**EL PASO COUNTY PLANNING AND
 COMMUNITY DEVELOPMENT
 DEPARTMENT**

CONSTRUCTION DRAWINGS CHECKLIST

OUTLOOK POWERS & GRINNELL

CIVIL CONSTRUCTION PLANS

OUTLOOK POWERS & GRINNELL
 NOTES

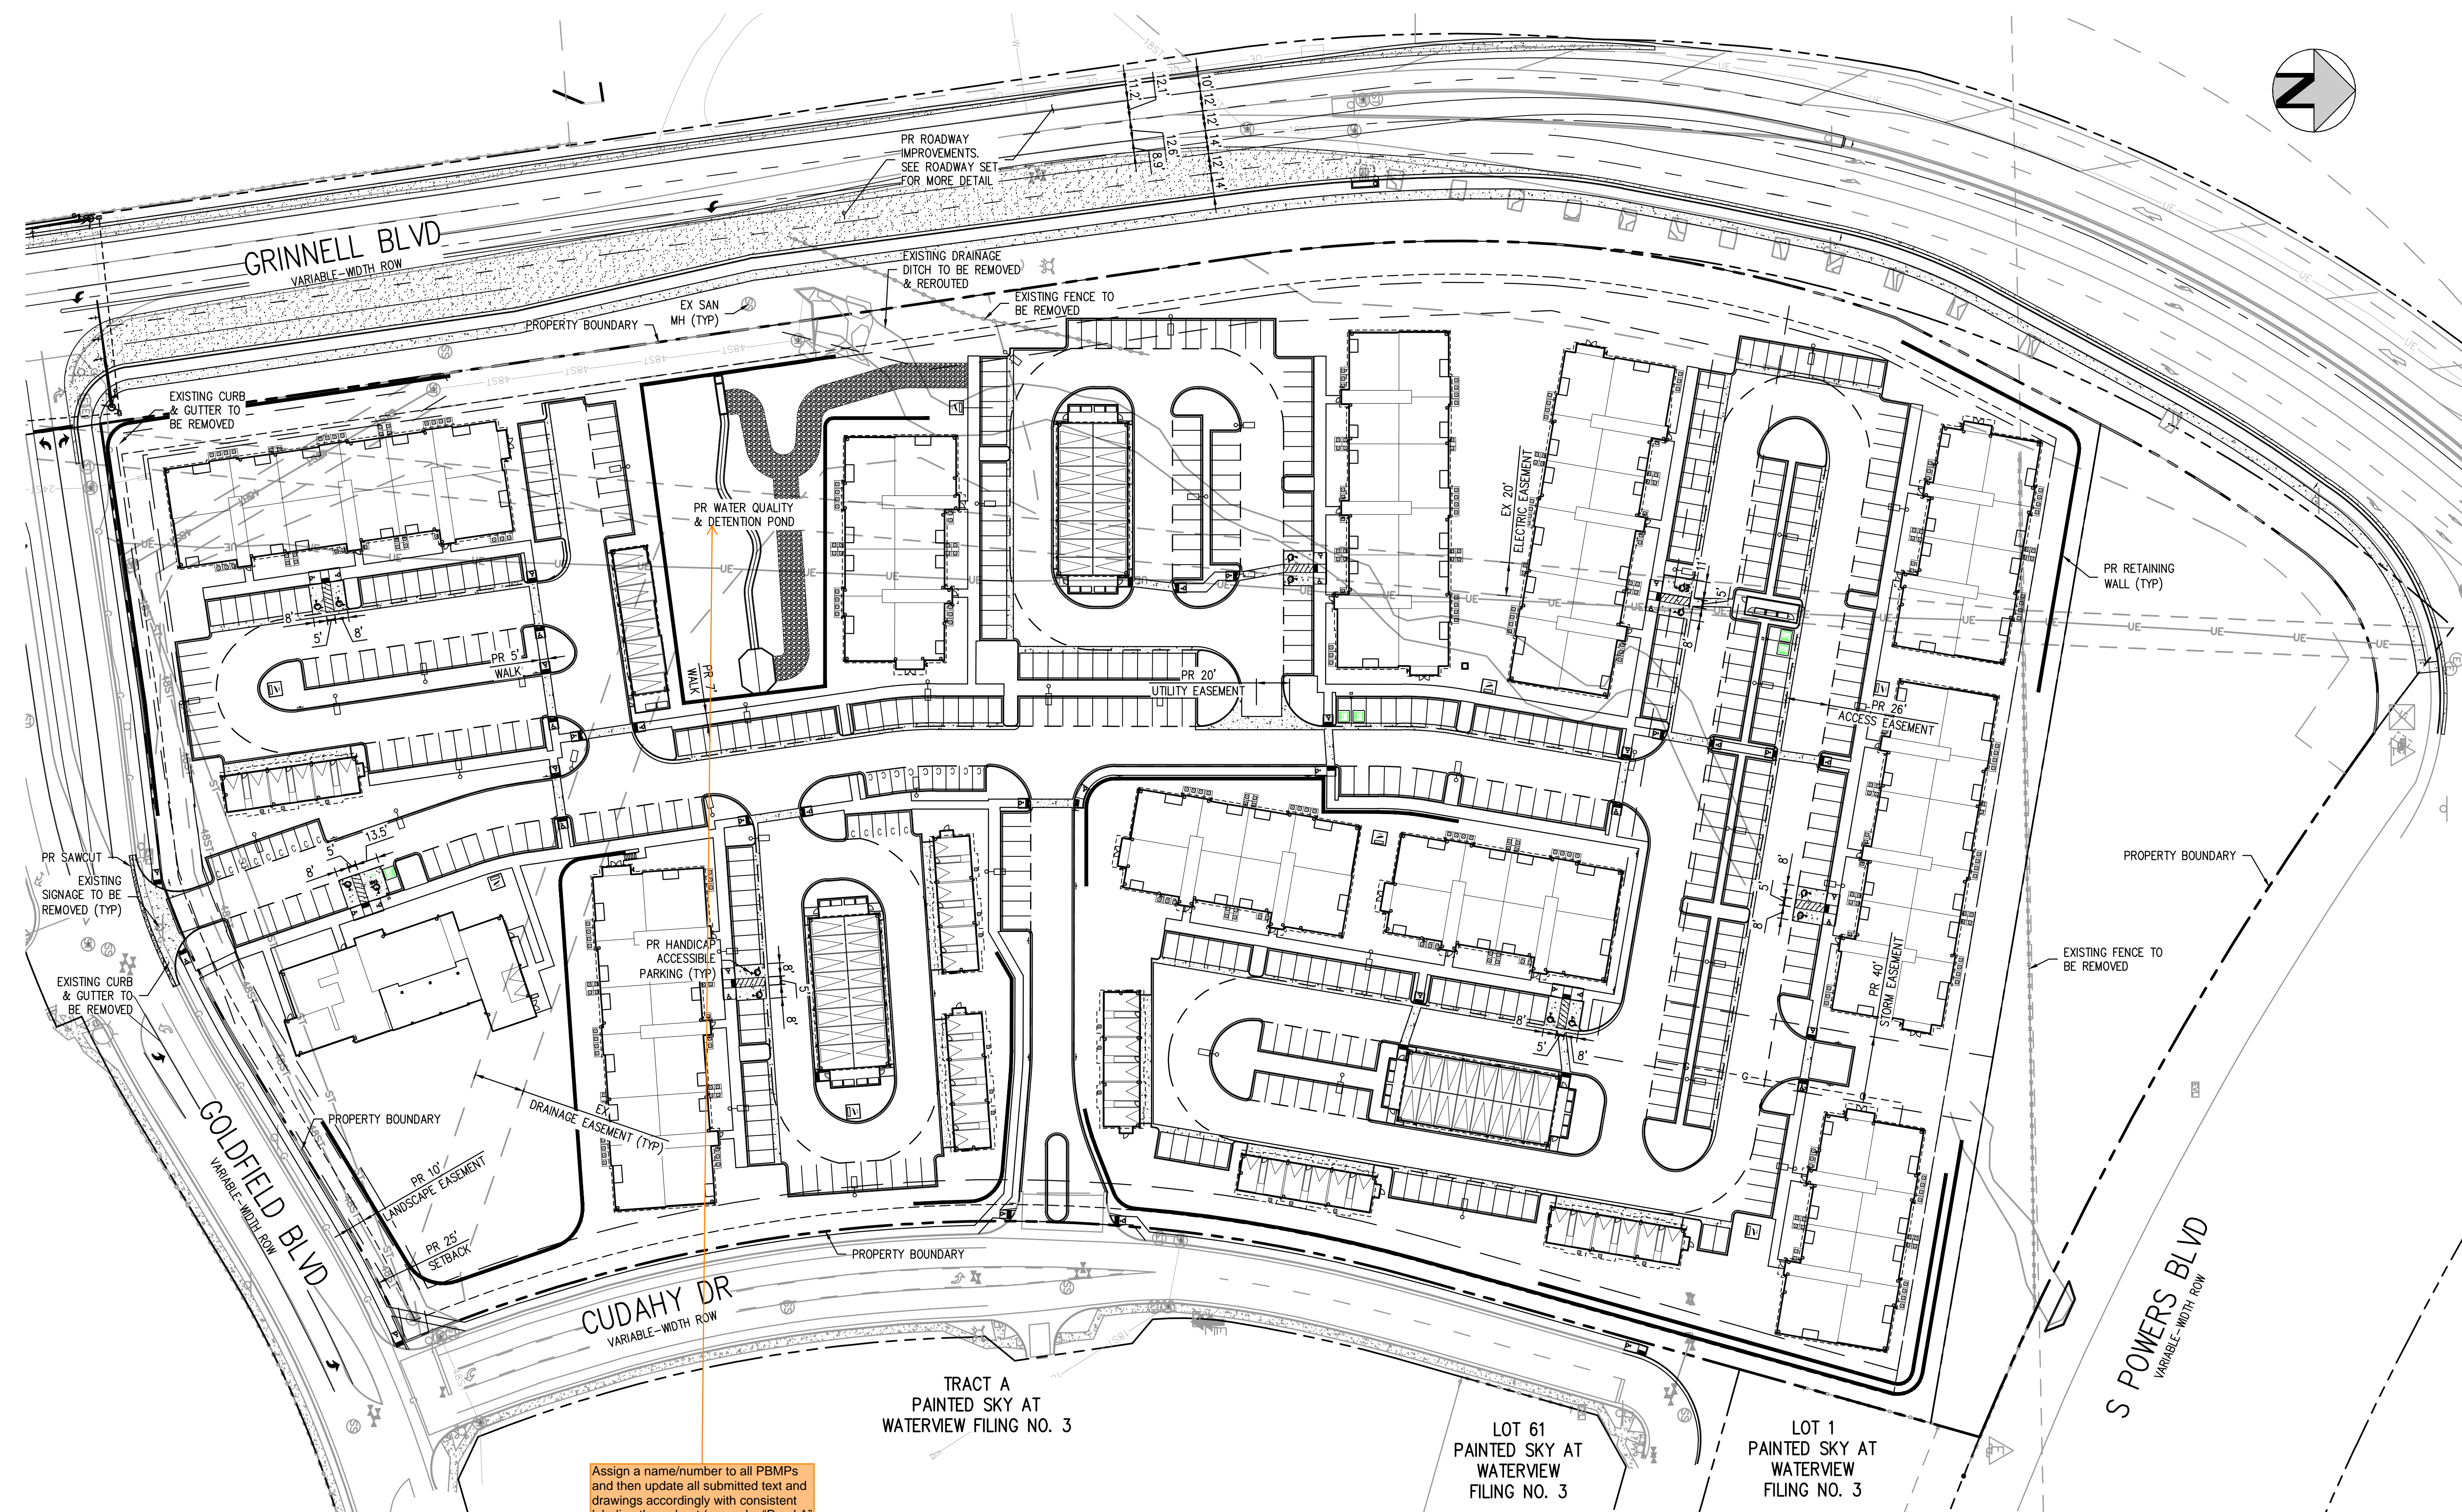
Provide legend for linetypes used

Add the EPC Construction plans notes.

OUTLOOK POWERS & GRINNELL
 OVERALL UTILITY PLAN

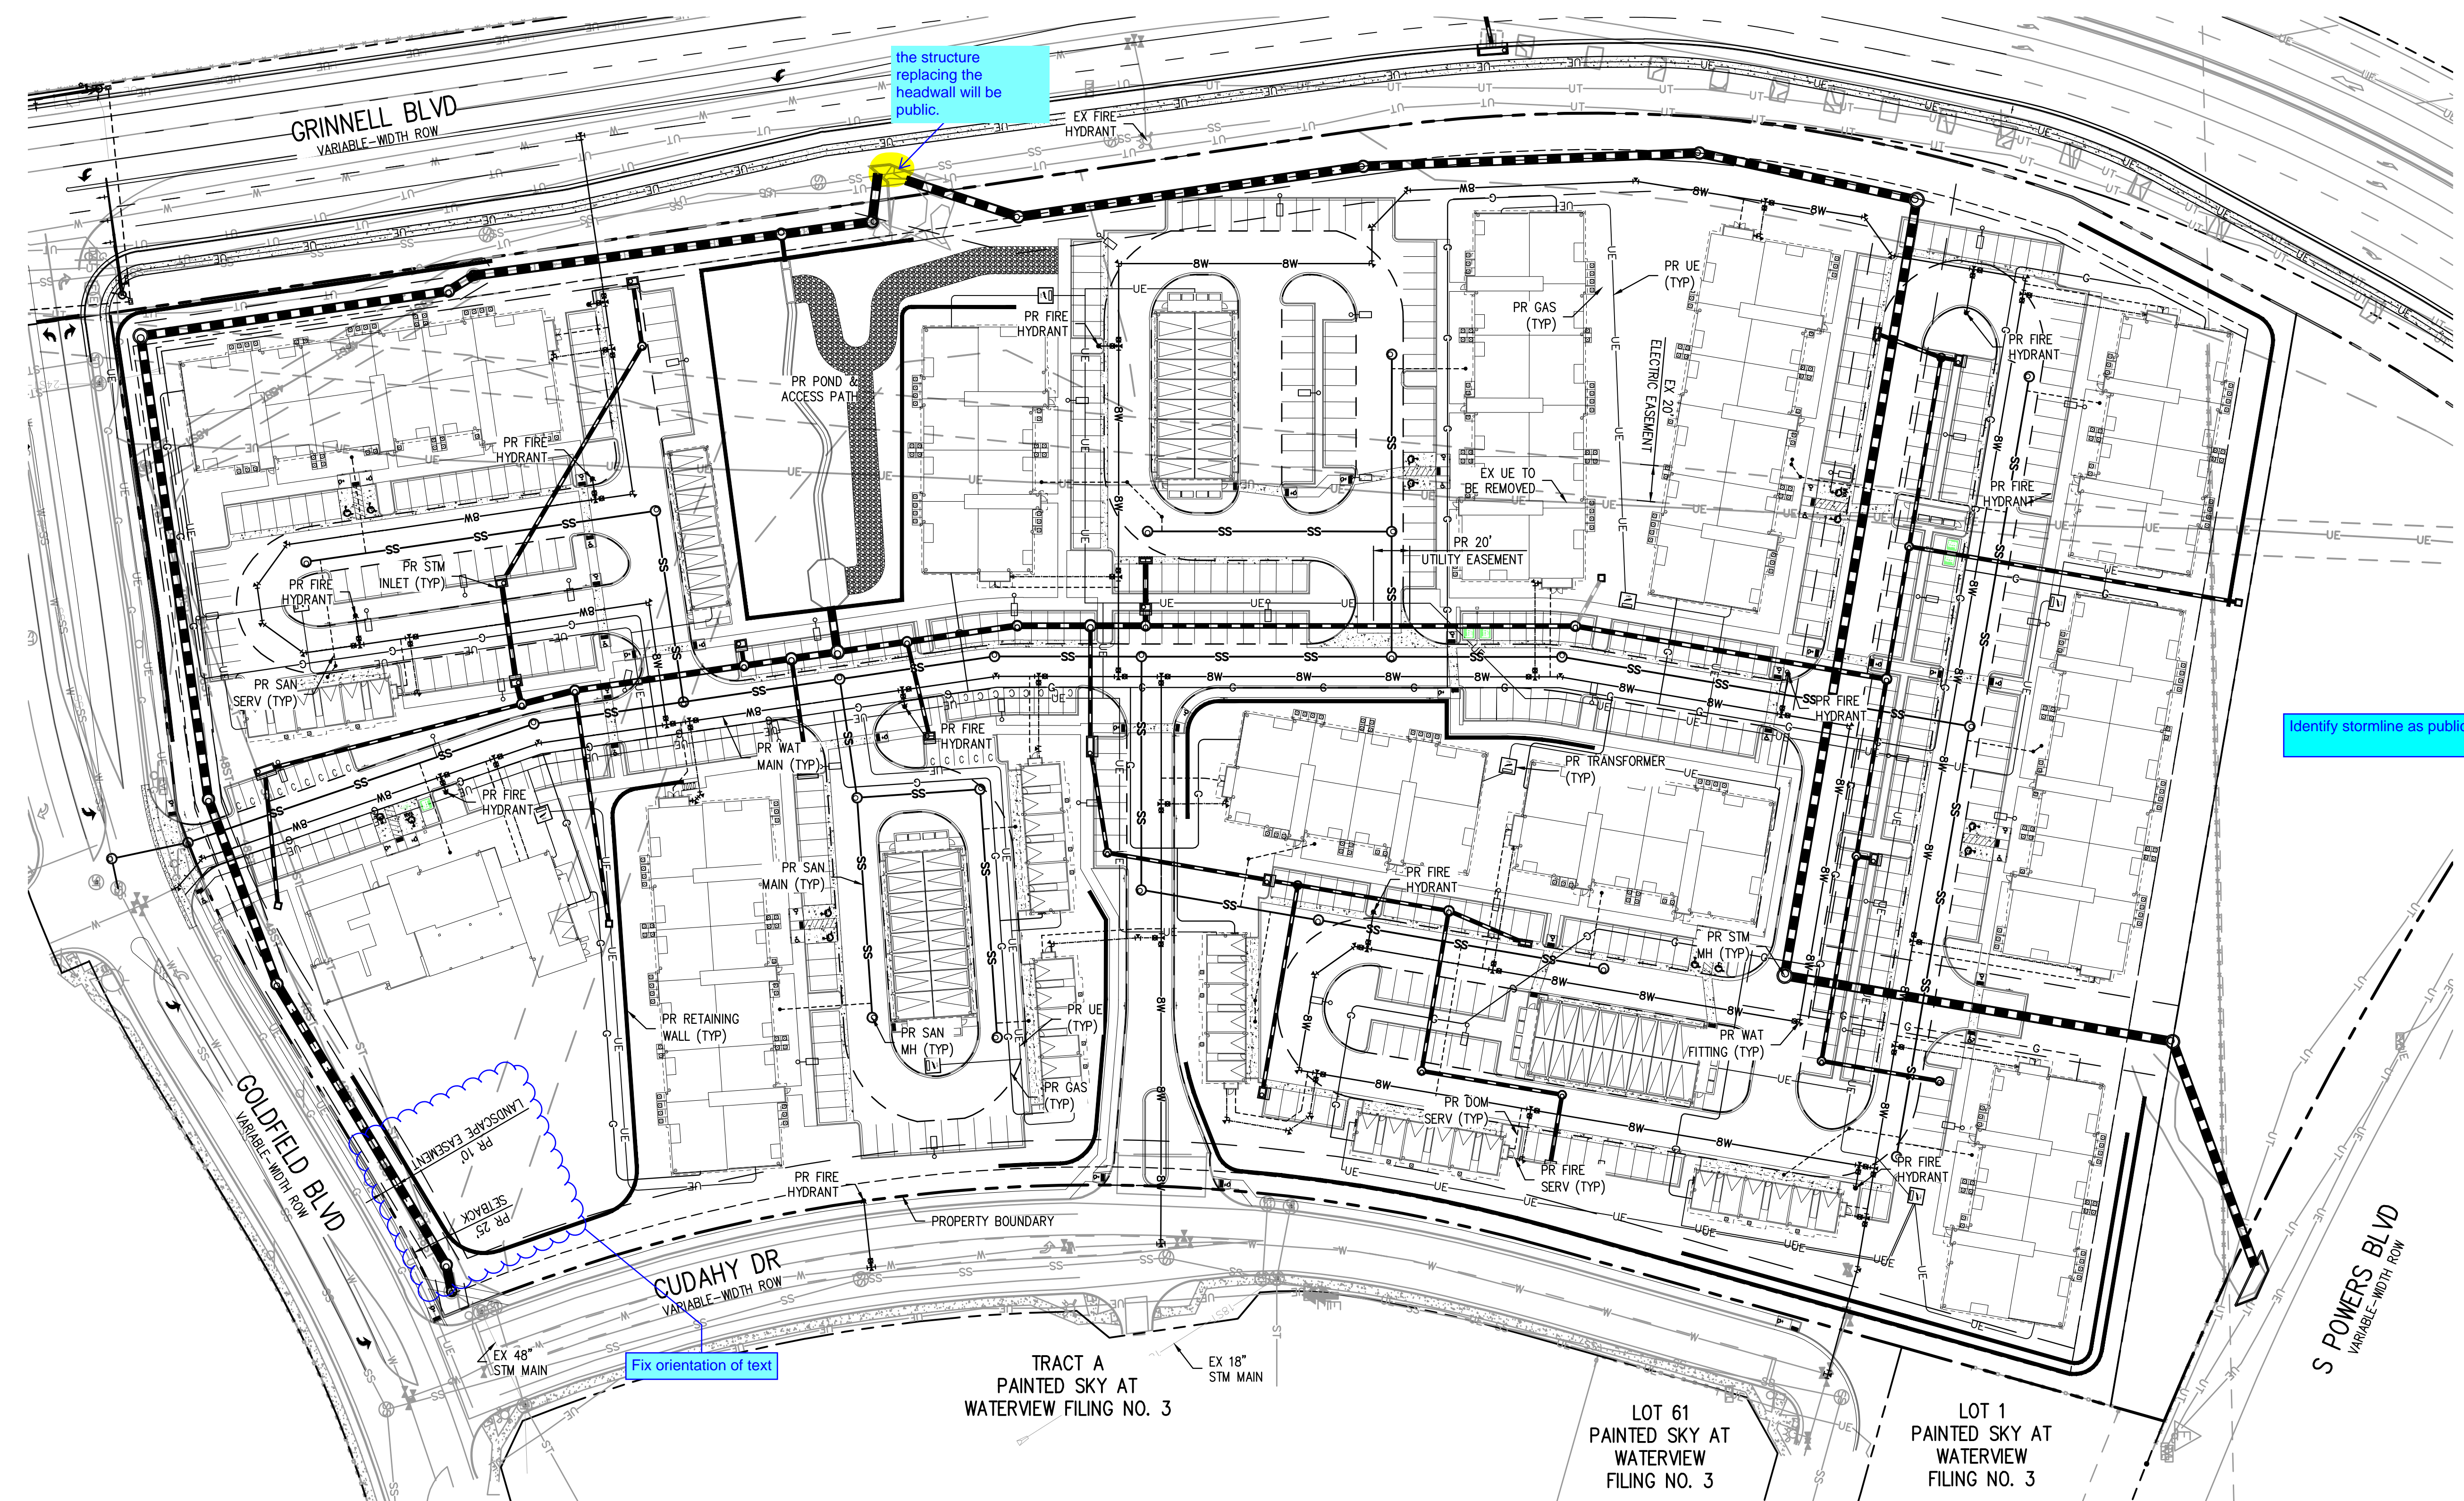
Identify stormline as public or private.

OUTLOOK POWERS & GRINNELL
 DRY UTILITY PLAN

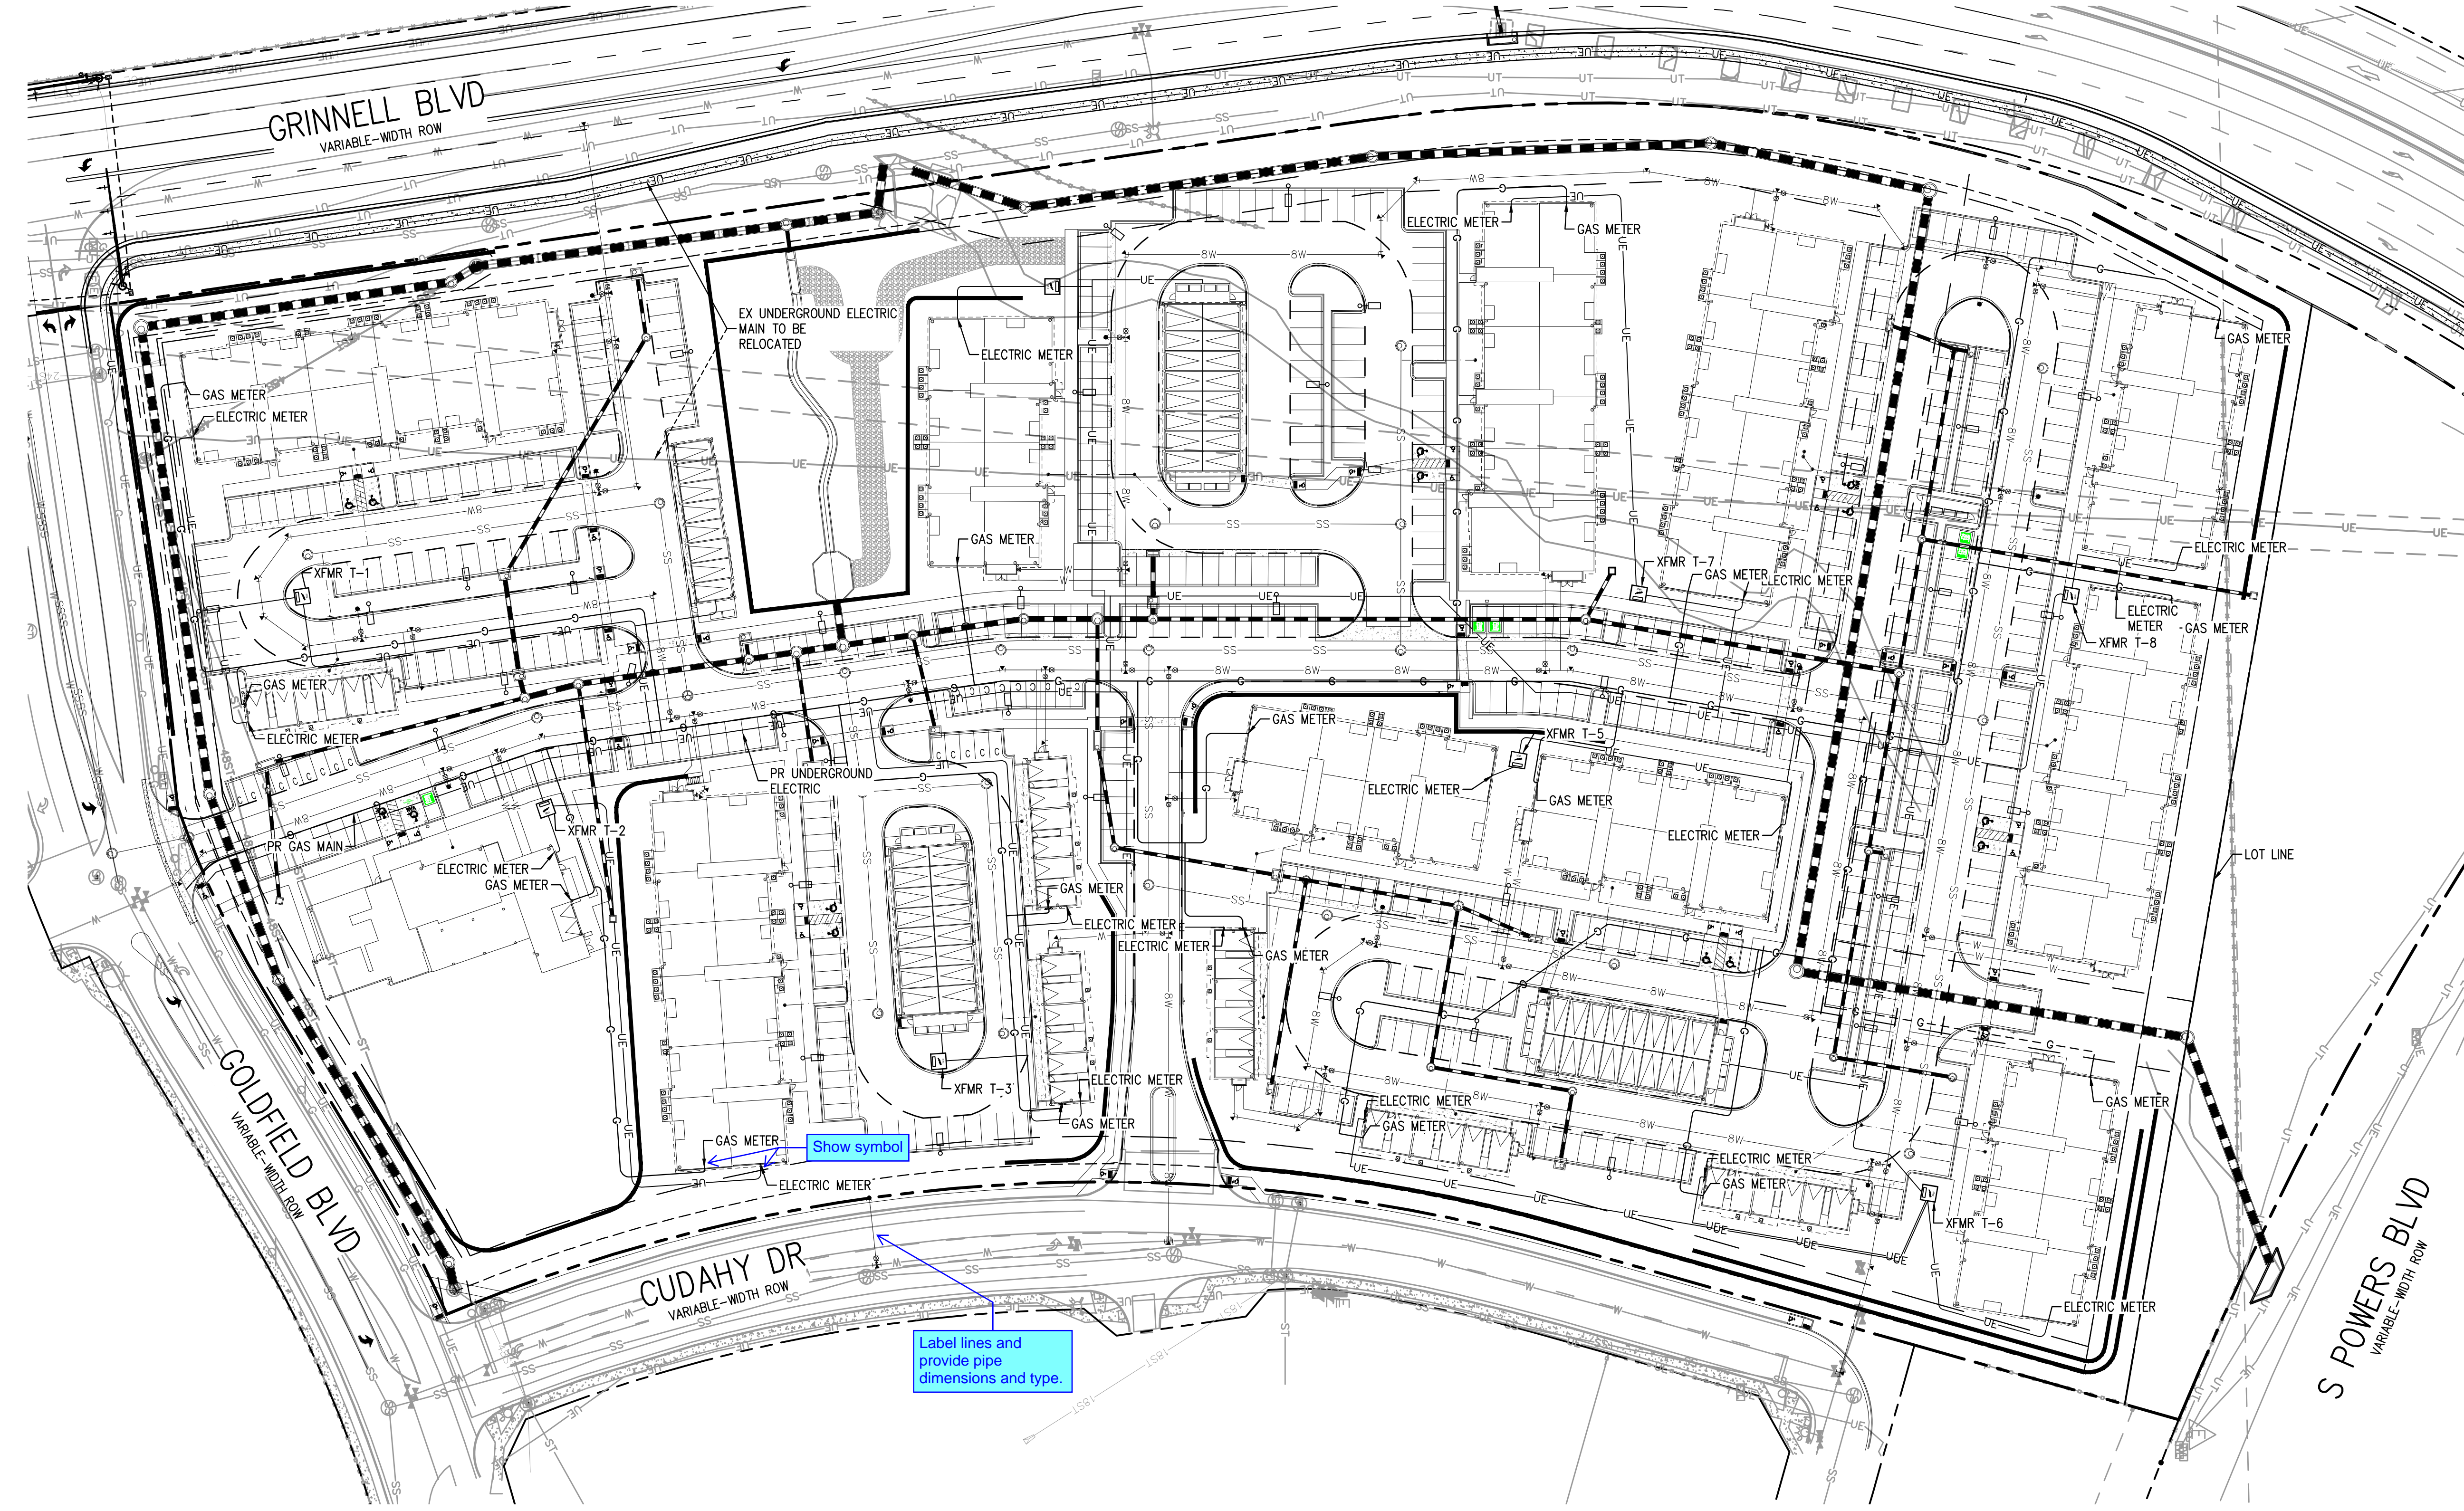
The swales in Basin areas E and M require underdrains per the drainage report. Show the underdrains and their tie into the storm sewer.

Label all swales and provide detailed cross section, include Sod and Permanent Irrigation requirements in accordance with Drainage Report Calculations.

Show symbol

Label lines and provide pipe dimensions and type.
